National Nuclear Security Administration

Subject: Solid Waste Management Unit (SWMU) 8 and 58 Proposed Groundwater Monitoring Well Location Adjustment

On January 28, 2011, the New Mexico Environment Department (NMED) approved the Groundwater Monitoring Well Installation Work Plan (Work Plan) for SWMUs 8 and 58. Included in this Work Plan were two diagrams showing proposed locations for groundwater monitoring wells CCBA-MW1 (associated with SWMUs 8 and 58 Feature OO) and CCBA-MW2 (associated with SWMUs 8 and 58 Feature YY).

Figure 2
Proposed Location for
Monitor Well CCBA-MW1
at SWMUs 8 and 58

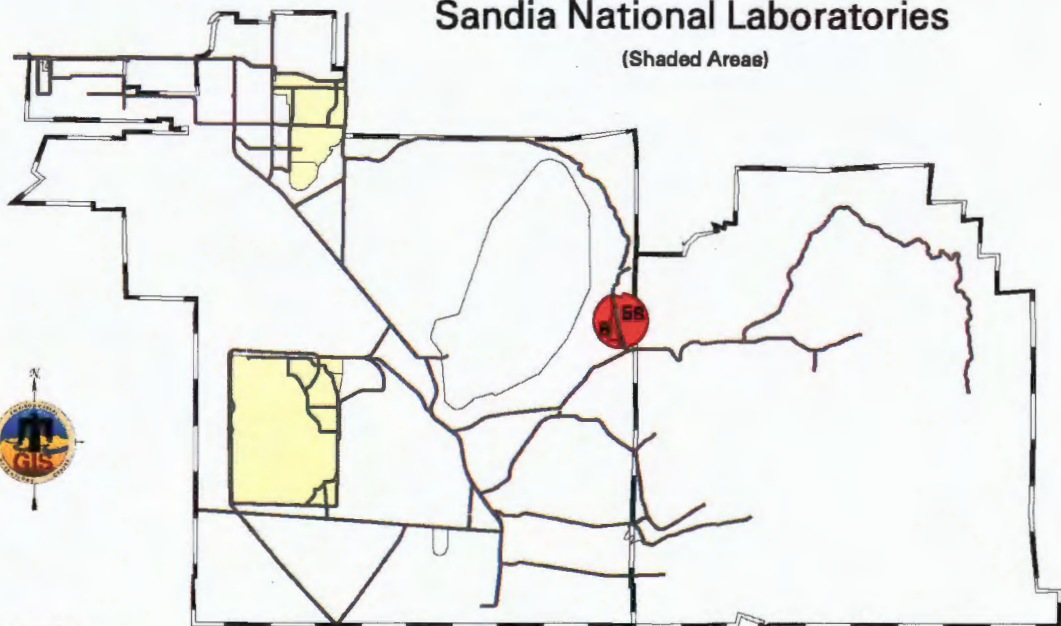
As part of the planning and preparation process for installation of these two wells, two issues were identified by DOE and SNL/NM. First, as shown on Figure 2, a Cultural Resource Area was identified immediately adjacent to the proposed location for well CCBA-MW1. Access to the proposed drilling location would require driving drilling equipment across the Cultural Resource Area which is prohibited. Second, the biological survey conducted in advance of the drilling for well CCBA-MW2 (shown on Figure 3) determined that the proposed location was within the nesting area of a State threatened bird species that could be impacted by drilling activities.

As a result of these two identified issues; NMED was contacted to discuss possible adjustments to the two well locations proposed in the Work Plan. As a result of a site inspection with the NMED at SWMUs 8 and 58 on April 12, 2011, alternative locations were selected for the two wells, which were marked in the field with pin flags at that time. The original and adjusted locations for well CCBA-MW1 and CCBA-MW2 are shown on Figures 2 and 3, respectively. DOE along with SNL/NM requests that NMED formally approve the proposed adjusted locations for these two monitoring wells.
